UNITED STATES PATENT AND TRADEMARK OFFICE

APPLICATION NO.	FILING DATE	FIRST NAMED INVENTOR	ATTORNEY DOCKET NO.	CONFIRMATION NO.
10/708,099	02/09/2004	Sebastian Strauss	BMCA9159.389	2098
27062	7590	08/18/2004	EXAMINER	
BOMBARDIER RECREATIONAL PRODUCTS LEGAL SERVICES - ST. BRUNO PO BOX 230 NORTON, VT 05907-0230			KWON, JOHN	
			ART UNIT	PAPER NUMBER
			3747

Office Action Summary	Application No.		Applicant(s)	
	10/708,099		STRAUSS, SEBASTIAN	
	Examiner		Art Unit	
	John T. Kwon		3747

DETAILED ACTION

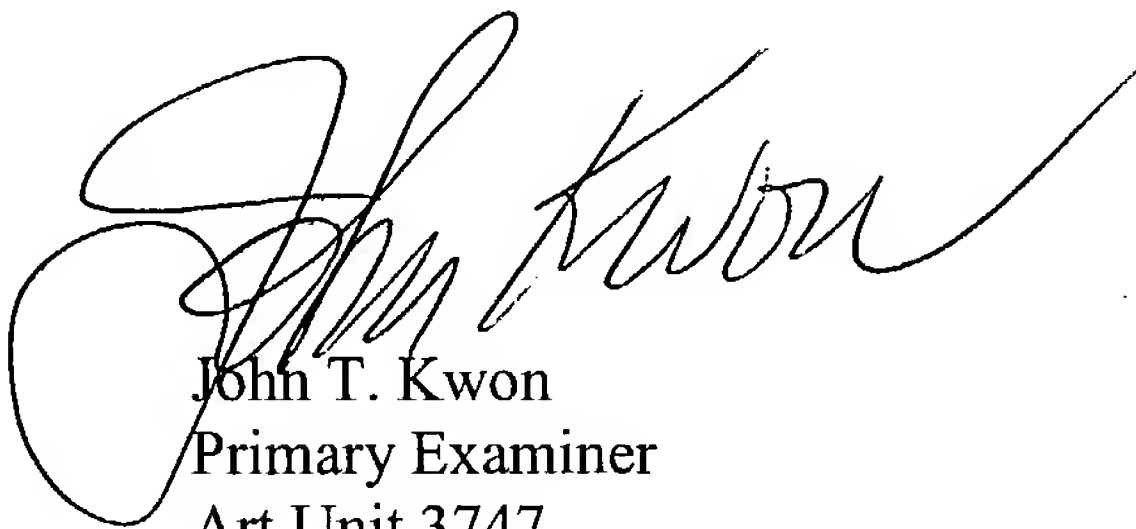
Claims 5, 6, 17, 22, 30 are rejected under 35 U.S.C. 103(a) as being unpatentable over Watson (US 5 829 407). Watson discloses a first zone having an axis of symmetry generally aligned with a cylinder bore, a second zone having an axis of symmetry generally aligned with a fuel spray projection from a fuel injector, and wherein the axis of symmetry of the second zone is skewed and offset from the axis of symmetry of the first zone. Regarding claimed particular shape of the first zone and the application of the invention, it would have been considered to be an obvious choice of mechanical design because one skilled in this art is familiar with basic

combustion chambers and normally has the laboratory test facilities. To optimize or select the suitable shape and the application would be within the ability of ordinary skilled in this art.
